**M2 Site within the North Ryde Station Urban Activation Precinct SSDA
5093**

North Ryde Station Precinct

State Significant Development Application – M2 Site

29 October, 2014

Figure 4 - Amendment 1 Road Network

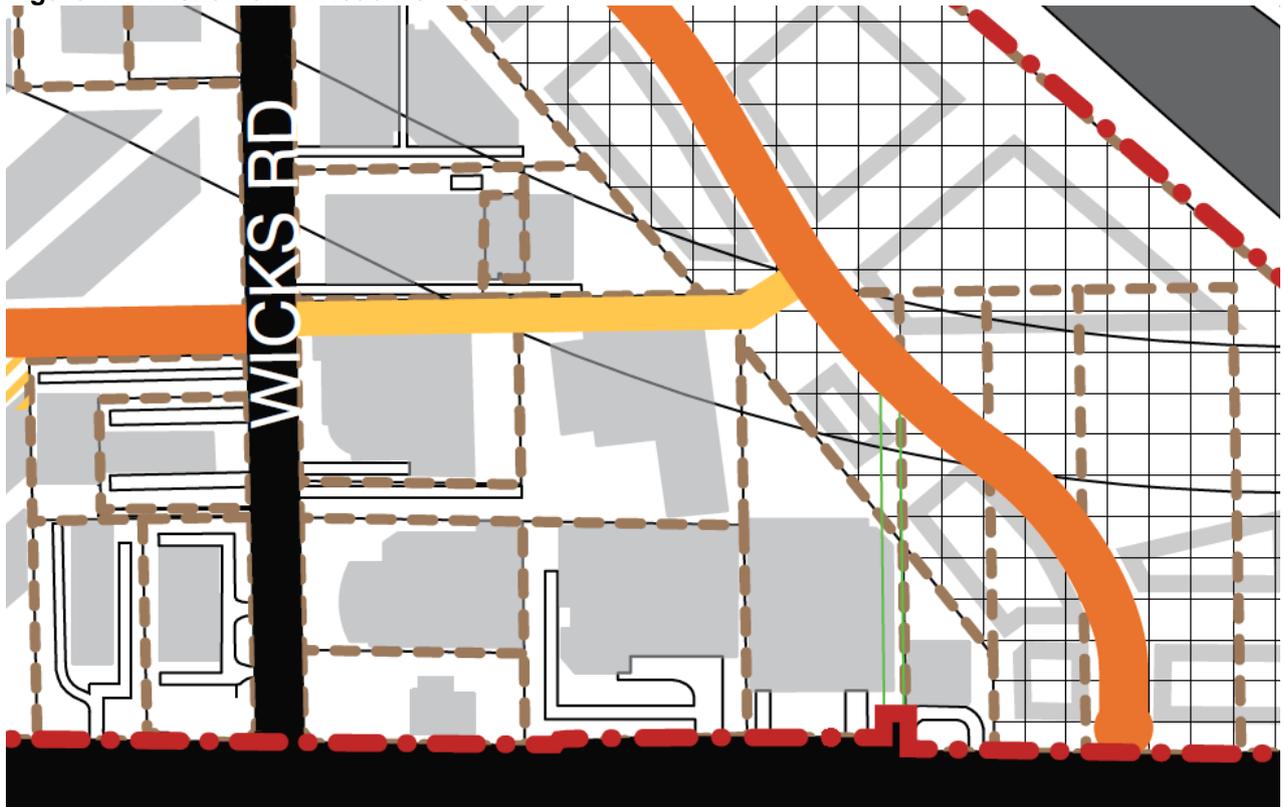
It is noted that the proposed subdivision plan has identified Lot 109 as being the location of a future road connection. Council is currently in the process of finalising a Planning Proposal for Macquarie Park which seeks to rationalise the road network detailed within the existing controls. This Planning Proposal and supporting documents is generally referred to as Amendment 1. Amendment 1 identifies that the proposed road connection is to be located at the northern most boundary of 11 and 113 Wicks Road. This proposed road network is detailed within Figure 4.

The road connection as identified is predicated on a recent planning proposal that was not supported by Council seeking residential land uses on 111 Wicks Road, 29 Epping Road, 31-35 Epping Road, Macquarie Park. This planning proposal is currently undergoing a Gateway Review with no definitive outcome at this stage.

As such, Council strongly recommends the amendment of the SSSA to reflect the future controls proposed for Macquarie Park.
